SUBJECT: COMANCHE PEAK NUCLEAR POWER PLANT, UNITS 3 AND 4
DOCKET NUMBERS 52-034 AND 52-035
RESPONSE TO REQUEST FOR ADDITIONAL INFORMATION NO. 5755
(SECTION 14.3.7)

RAI NO.: 5755 (CP RAI #220)

SRP SECTION: 14.03.07 - Plant Systems - Inspections, Tests, Analyses, and Acceptance Criteria

Figure 9.4-203 UHS ESW Pump House Ventilation Systems Flow Diagram

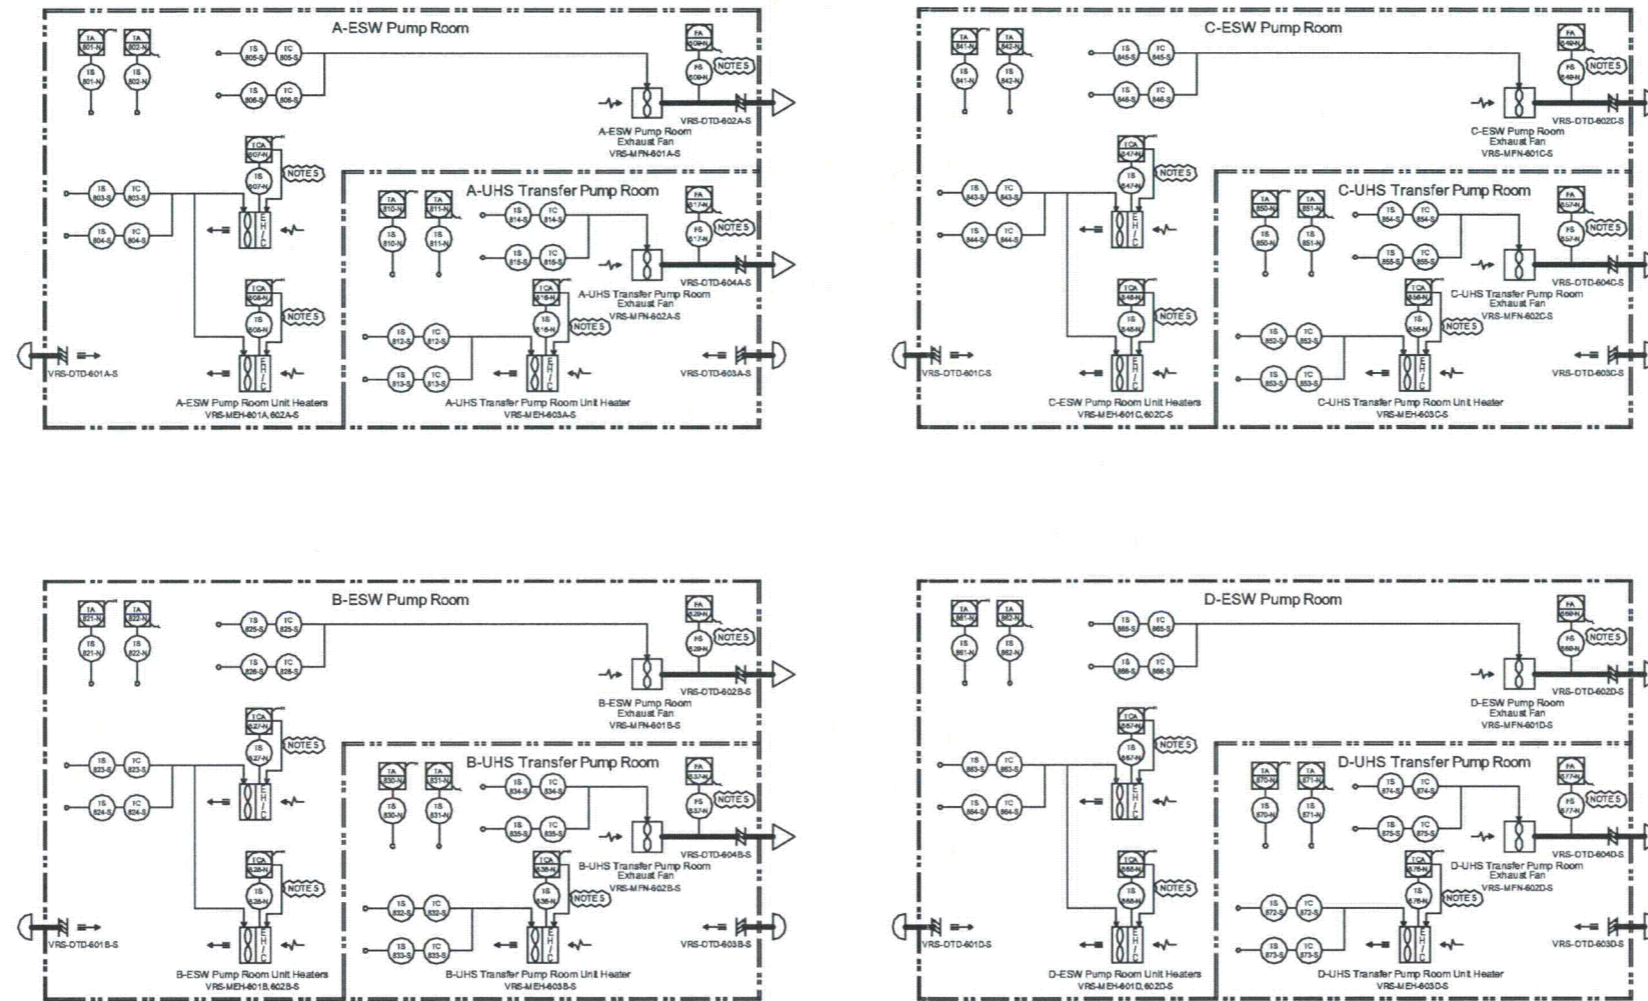
The staff also notes that the temperature and flow instrumentation attached to the room heaters and exhaust fans would be classified as seismic category II (as a minimum threshold with respect to plant safety). The staff requests additional information about the seismic classification and about the basis for the classification of all instrumentation (i.e. including alarm temperature switches) displayed in Figure 9.4-201 and that the applicant update as necessary FSAR Tables 3.2-201 and A.2-2.

All the instrumentation displayed in FSAR Revision 1 Figure 9.4-201 (FSAR Draft Revision 2 Figure 9.4-203) is designed in accordance with DCD Subsection 3.2.1. The non-safety related temperature and flow instrumentation attached to the unit heaters and exhaust fans is classified as seismic category II in accordance with the design bases described in DCD Subsection 3.2.1. Figure 9.4-201 has been revised to add a note that the non-safety related instrumentation attached to the unit heaters and exhaust fans is classified as seismic category II. Table A.2-2 addresses only safety-related equipment. Consistent with DCD Table 3.2-2, FSAR Table 3.2-201 does not list specific instruments. Therefore, no update is necessary for Table A.2-2 or Table 3.2-201 to include non-safety related instrumentation.

See attached marked-up FSAR Draft Revision 2 Figure 9.4-203.

- NOTE
1. ALL FANS, DAMPERS AND HEATERS IN THIS SHEET ARE DESIGNATED IN ACCORDANCE WITH SEISMIC CATEGORY I.
 2. BACKDRAFT DAMPERS ARE MOUNTED IN THE WALL OPENING.
 3. THERE IS NO DUCTWORK IN THE VENTILATION SYSTEMS.
 4. EXHAUST FANS ARE WALL-MOUNTED.
 5. THE ANNOTATED INSTRUMENTATION IS SEISMIC CATEGORY II.
